# TECHNICAL BULLETIN

DATE: 26 JULY 2010  
PAGE 1 OF 6

\* Supersedes SL900-016, dated 14 AUG 1996. Revised to correct REPLACEMENT PARTS/SUPPLIES Table.

## SECONDARY EJECTOR OIL BREATHER FITTING MODIFICATION

**Figure 1. Ejector Fitting Modification**

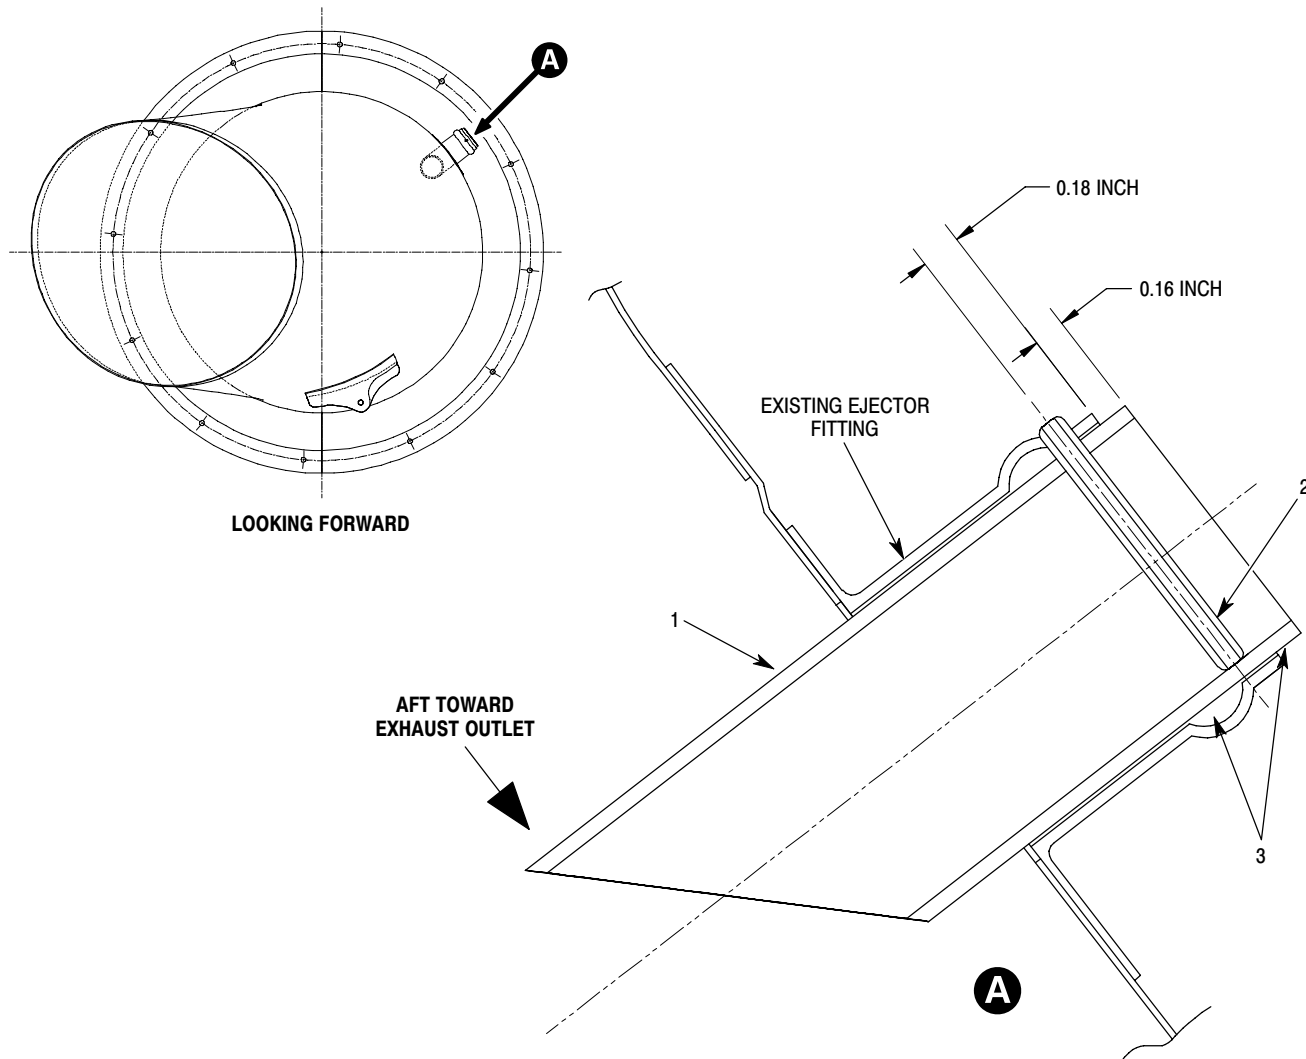
MDHI has developed a modification to the engine exhaust secondary ejector oil breather fitting to eliminate engine oil seeping back into the engine compartment and aft cowlings from the engine oil breather tube. This procedure is provided to allow operators to do this modification. There have been part changes since SL900-016.

- (3). Apply sealant (3) (C215). (Ref. CSP-900RMM-2, Section 20-50-00, and CSP-SPM, Section 20-30-00).
  - (a). Apply to inside diameter of existing nipple at mating surface bead location with a quantity which will contact the tube outside diameter upon installation. Remove excess sealant.
  - (b). Apply a bead of sealant around outside diameter at tube (1) to nipple edge. (Ref. Figure 1, item 3 ).

**NOTE:** Ref. Figure 1. Incorrect orientation of tube will pressurize engine gearbox.

- (1). Install tube (1). The 45 degree angle mouth must be positioned to face aft toward ejector outlet.
- (2). Install pin (2).
  - (a). Drill 0.122 to 0.128 inch (3.1 to 3.25 mm) diameter hole through wall of fitting and tube (orientation around outside diameter is optional) on tube centerline and to dimensions shown.
  - (b). Install (press fit) pin (2) until it bottoms out on tube inside diameter.

**NOTE:** If necessary open hole to the minimum diameter to install pin (2).

- (c). Grind off end of pin (2) flush to bead of fitting.
